FIGURE 3.7.3-1

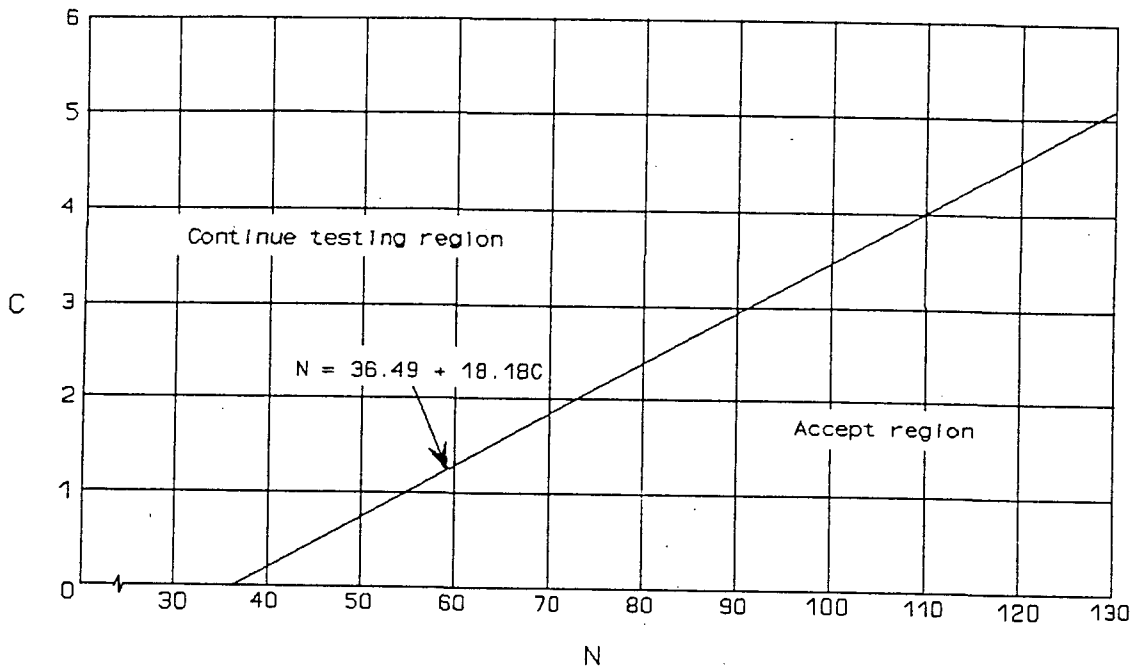
1. An initial representative sample of 37 snubbers shall be functionally tested in accordance with Figure 3.7.3-1. For each snubber type which does not meet the functional test acceptance criteria of Table 3.7.3-5, another sample of at 19 snubbers shall be tested. The results from this sample plan shall be plotted using an "Accept" line which follows the equation $N = 36.49 + 18.18C$. If the point plotted falls on or below the "Accept" line, testing of that type of snubber may be terminated. If the point plotted falls above the "Accept" line, testing must continue until the point falls in the "Accept" region or all the snubbers of that type have been tested.
-

CF 95-030

The 37 test plan has been clarified and the 55 plan has been abandoned as issued in subsection ISTD of ASME OM Code-1995. A combination of the 37 plan and the 10% plan is best suited for WBN's population of snubbers (i.e. \approx 900 mechanical snubbers and 20 hydraulic snubbers). See App. D of ISTD for comparison of the plans.

FIGURE 3.7.3-1

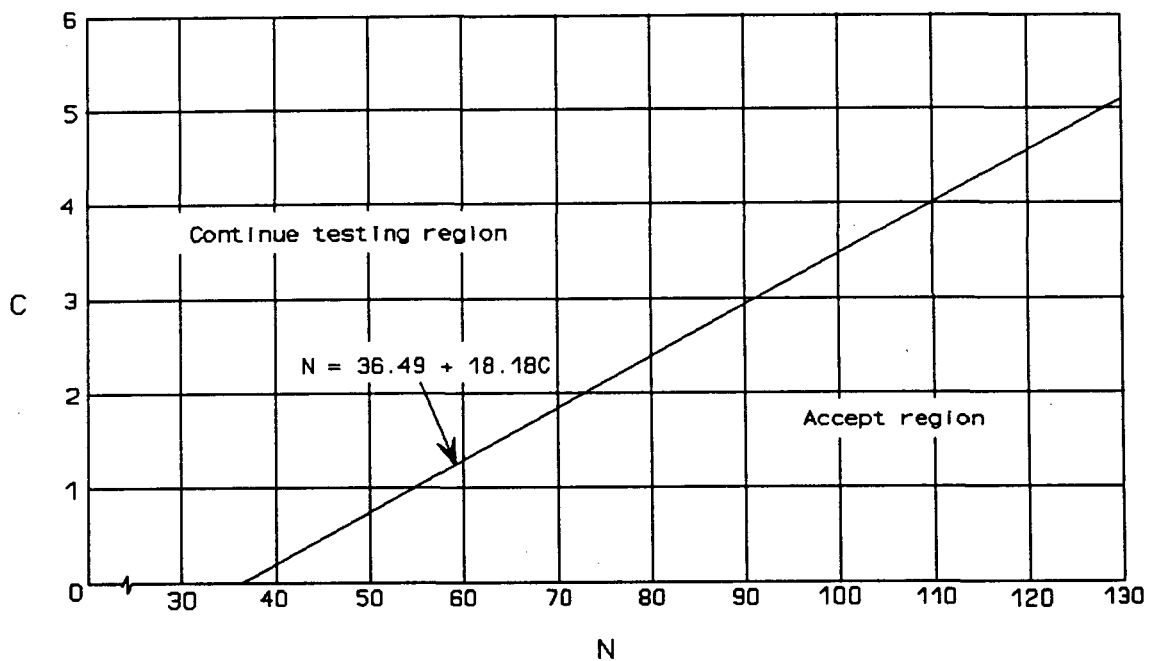
1. An initial representative sample of 37 snubbers shall be functionally tested in accordance with Figure 3.7.3-1. For each snubber type which does not meet the functional test acceptance criteria of Table 3.7.3-5, another sample of at 19 snubbers shall be tested. The results from this sample plan shall be plotted using an "Accept" line which follows the equation $N = 36.49 + 18.18C$. If the point plotted falls on or below the "Accept" line, testing of that type of snubber may be terminated. If the point plotted falls above the "Accept" line, testing must continue until the point falls in the "Accept" region or all the snubbers of that type have been tested.
-
